ADDENDUM NO. 1

PROJECT: Renovations to Foley Community Hall, Seguin Township
60 Rankin Lake Road, Seguin, ON

PROJECT No: 24-43

DATE: November 9, 2026

DRAWN: D.R.
CHECKED: D.R.
SCALE: 1/2"=1'
SHEET NUMBER: ADD1-1

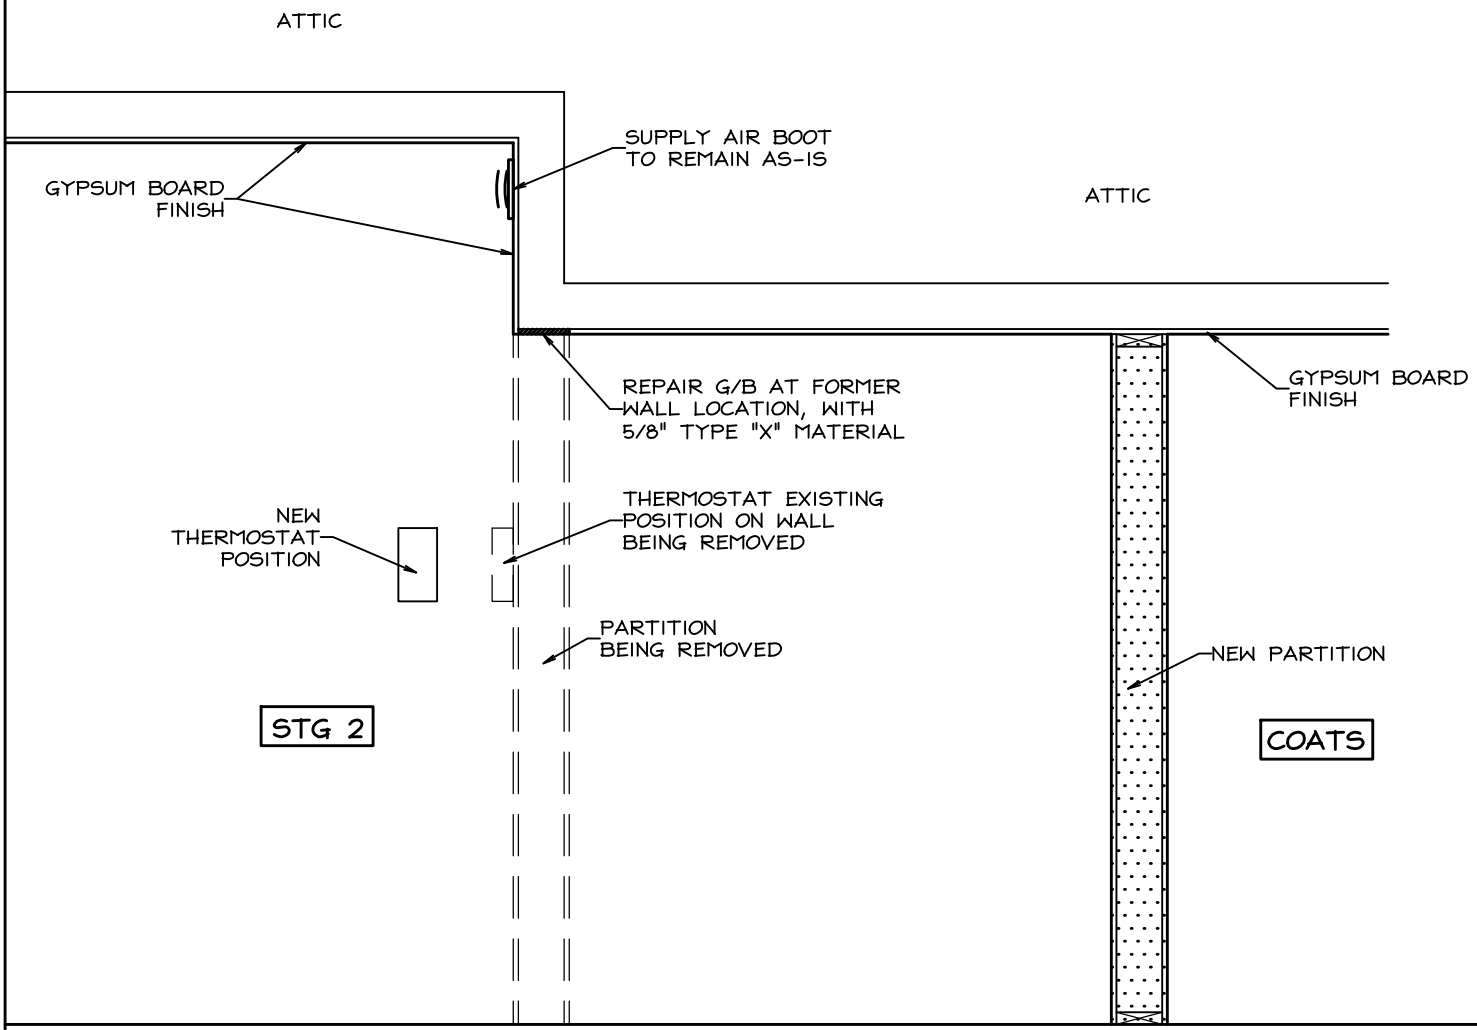
1. Refer to drawing A-2. The existing wall between STG 2 and Coats has a thermostat and an air supply boot mounted on it. The ceiling of Coats is lower than the ceiling of STG 2. Sketch ADD1-1, enclosed, shows the old wall to be removed only to the jog in the ceiling, leaving the supply boot where it is. Relocate the thermostat as indicated.

1. DIMENSIONS ARE TAKEN TO FACE OF BLOCK, FACE OF STUD, AND CENTERLINE OF COLUMN.

DRAWN: X.X.
CHECKED: D.R.
SCALE: 1"=1'-0"
SHEET NUMBER: ADD1-2

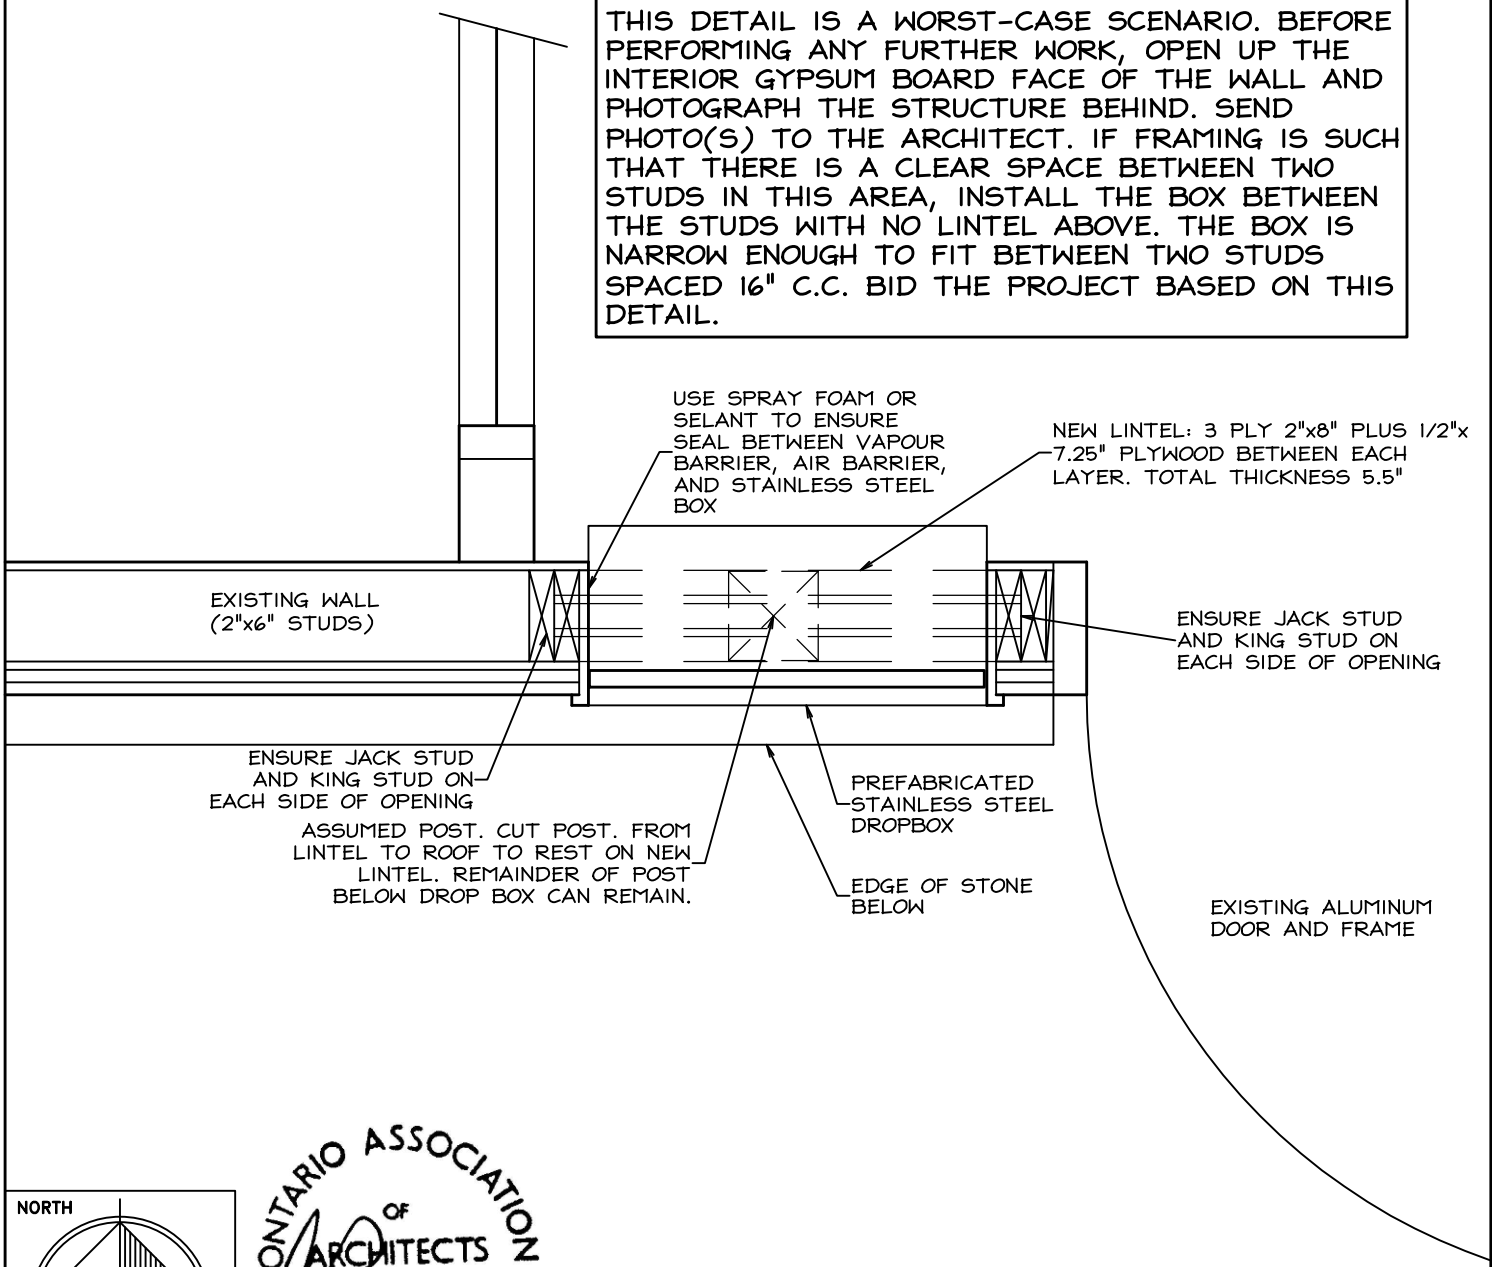
2. Book Drop Box Detail: Refer to drawings A-2 and ADD1-1. The book drop box shown on original drawing A-2 is model "K-TWV Valustar Thruwall" by Kingsley Companies. Drawing ADD1-1 enclosed provides added information on the installation.

1. INSTALL BOX IMMEDIATELY ABOVE THE EXTERIOR STONE WAINSCOT OF THE BUILDING.

THIS DETAIL IS A WORST-CASE SCENARIO. BEFORE PERFORMING ANY FURTHER WORK, OPEN UP THE INTERIOR GYPSUM BOARD FACE OF THE WALL AND PHOTOGRAPH THE STRUCTURE BEHIND. SEND PHOTO(S) TO THE ARCHITECT. IF FRAMING IS SUCH THAT THERE IS A CLEAR SPACE BETWEEN TWO STUDS IN THIS AREA, INSTALL THE BOX BETWEEN THE STUDS WITH NO LINTEL ABOVE. THE BOX IS NARROW ENOUGH TO FIT BETWEEN TWO STUDS SPACED 16" C.C. BID THE PROJECT BASED ON THIS DETAIL.
